MIL ON With DTC(s) P1C5F19 and/or P1C5D19 Causing Over-current Condition

Service Category Vehicle Interior

Section Meter/Gauge/Display

Figure 1. View of Terminals at the Inverter

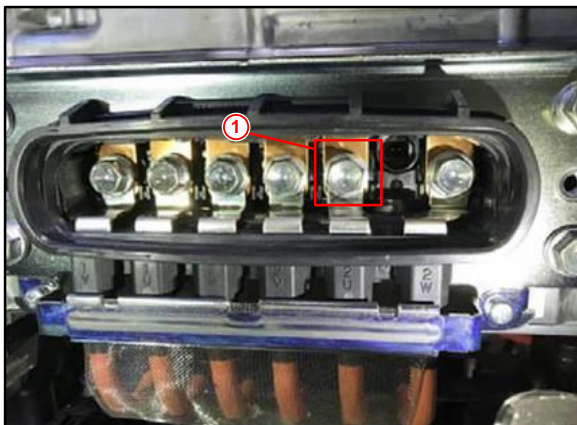
1 Close-Up View of Terminal (See Figure 2)

3. Using compressed air, blow out ALL potential debris on the terminals and connections area of the inverter and transaxle. Visually confirm there is no debris present on terminals and connections area.
4. Reinstall the MG cable with NEW bolts into the transaxle assembly. Inverter bolts can be reused. Refer to TIS, applicable model and model year Repair Manual:
 - [2019](#) / [2020](#) Avalon HV:
Drivetrain – Hybrid Transmission/Transaxle – “P710 (Hybrid Transmission / Transaxle): Motor Cable: Installation”
 - [2019](#) / [2020](#) Camry HV:
Drivetrain – Hybrid Transmission/Transaxle – “P710 (Hybrid Transmission / Transaxle): Motor Cable: Installation”
 - [2019](#) / [2020](#) RAV4 HV:
Drivetrain – Hybrid Transmission/Transaxle – “P710 (Hybrid Transmission / Transaxle): Motor Cable: Installation”

Figure 2. Close-Up View of Terminal

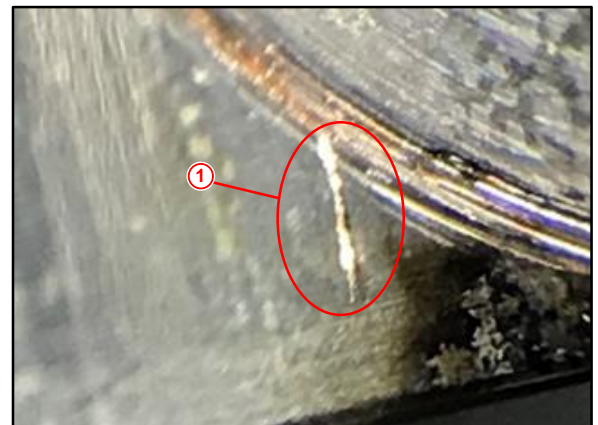
1 Debris Created From Bolt Tightening

Ensure correct fastening tools and torque are used when installing the MG cable. Over tightening can create debris.
